Upper Trishuli-1 HEP (216MW)

DOOSAN NEPAL BRANCH OFFICE	Address & Contact No. : Four Square Building, Naxal, Kathmandu, Nepal (P.O Box : 1387) + 977 1 692 3014	Project No. H20002	DOCUMENT DISPATCHED BY Courier Service ☐ Messenger ☐ Post-Air Freight ☐ Document System or E-mail ■ By hand ■
DOCUMENT DISTRIBUTION	■ POWER CHINA (Subcontractor) ☐ Doosan's Site Office		
SUBJECT	Review Note RN-0108_Outline Drawing of Diversion Tunnel Lining

REVIEW NOTE

Contractor	**Doosan Heavy Industries & Construction Co., Ltd.**		
Title of the Document	Diversion Tunnel, outline drawing		
Document No.	UT1-C-010-CVL-DG-42005	Revision	0A
Date of Documents	15.03.2022	Received Date	16.03.2022
Transmittal Form No.	UT1-HEP-DHI-D-0184		
Previous Review Date/Status	N/A	Prev. Review Note No.	N/A
Review Note No.	**RN-0108**	**Present Review Date**	**30.03.2022**
		Present Review Status	**RR**

LONGITUDINAL PROFILE OF DIVERSION TUNNEL

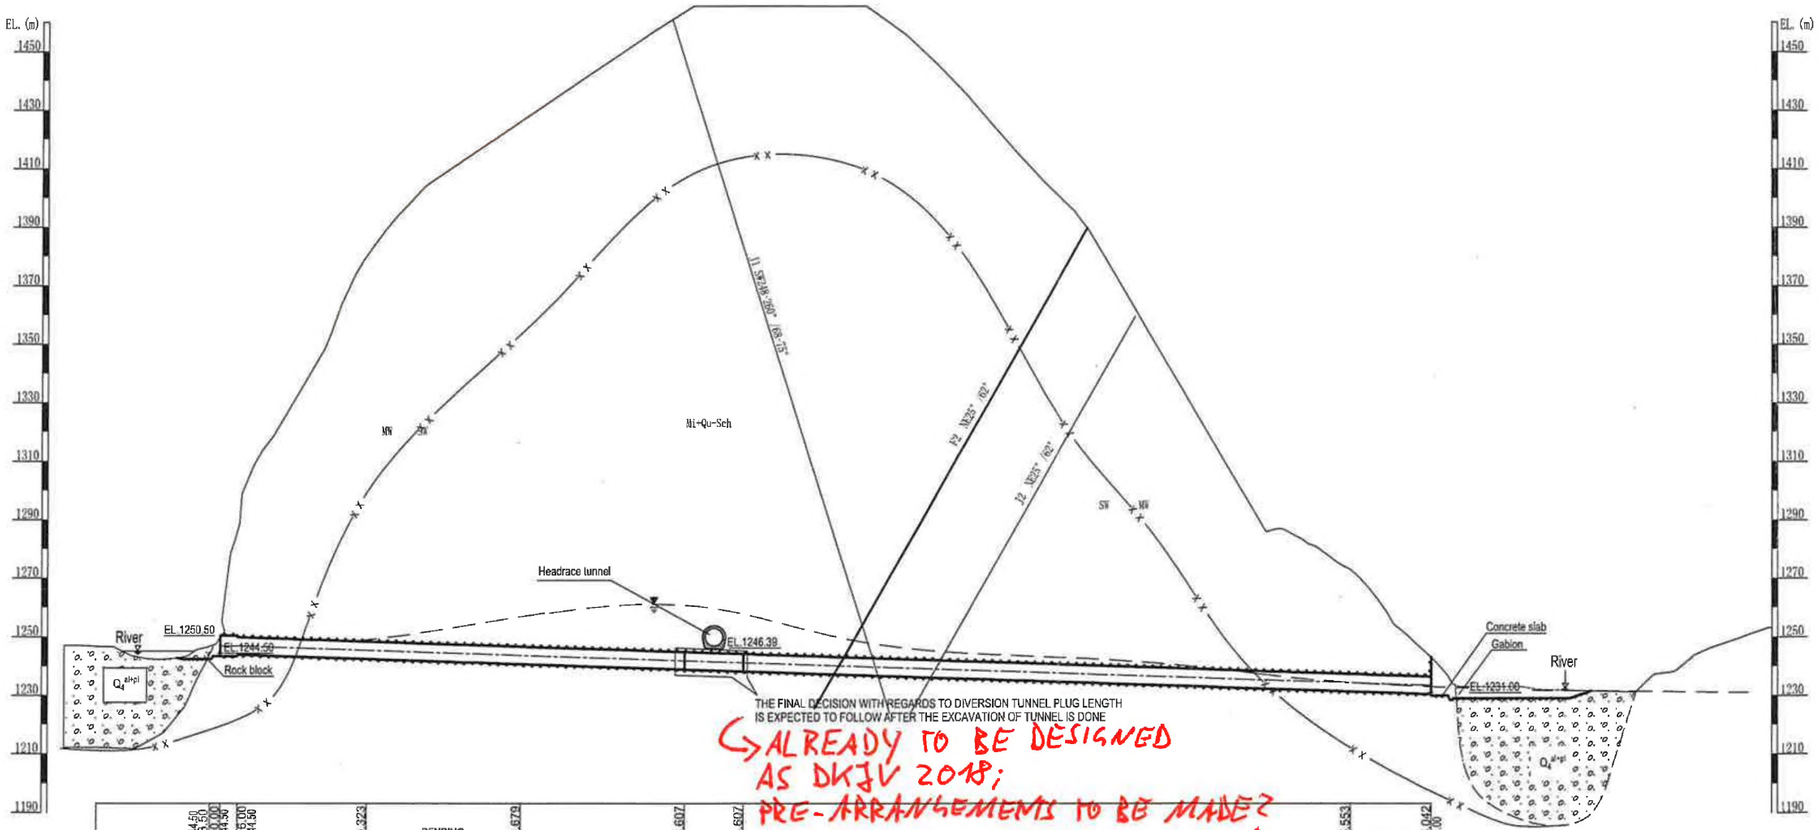
ALREADY TO BE DESIGNED AS DKJV 2018; PRE-ARRANGEMENTS TO BE MADE?

COMMENTS TO SHEET 2 OF THIS DOCUMENT ARE VALID AS WELL.

TYPICAL CROSS SECTION D1
(for rock class II)

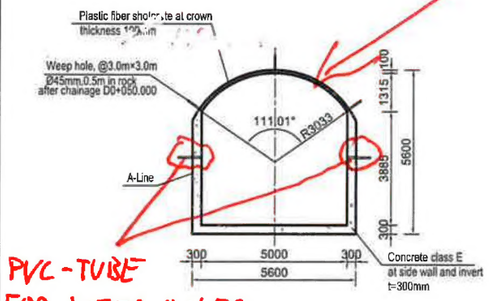
HIGH FLOW VELOCITIES WITH ABRASIVE MATERIAL SHALL BE CONSIDERED ⇒ FULL REINFORCED CONCRETE LINING SHALL BE CONSIDERED

TYPICAL CROSS SECTION D3
(for rock class IV)

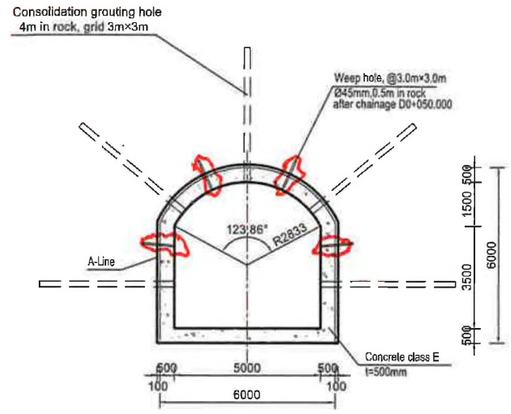
PVC-TUBE FOR WEEP HOLES IN REINFORCED CONCRETE LINING
↳ EPC CONTRACT ANNEX 13, PART C, 1. CONSTR. SPEC., 18.3.24.

TYPICAL CROSS SECTION D4
(for intersection of headrace and diversion tunnel)

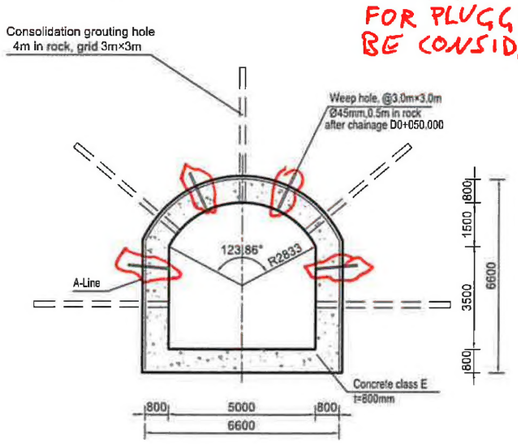
PRE-MEASURES FOR PLUGGING TO BE CONSIDERED?

TYPICAL CROSS SECTION D5
(for inlet section) / OUTLET SECTION?

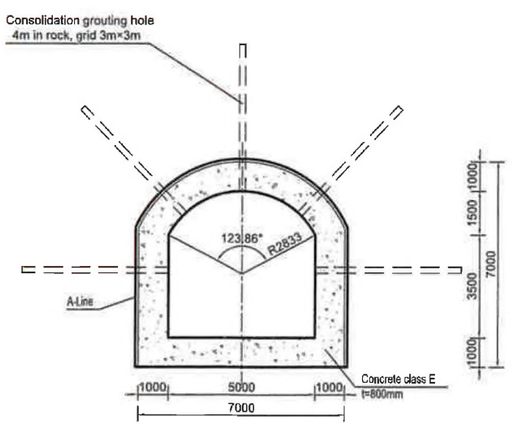
HORIZONTAL WATERSTOPS ACCORDING TO UT1-C-010-CVL-MS-80013, SUBCHAPTER 9.3.2(2) HAVE TO BE INDICATED WHERE APPLICABLE

- LEAN CONCRETE?
- WEEP HOLES IN TUNNEL BOTTOM SLAB?
- BLOCK JOINTS / DETAILS?
- TRANSITION CONCRETE LINING ↔ SHOTCRETE LINING TUNNEL ROOF? → HIGH FLOW VELOCITIES → CAVITATION
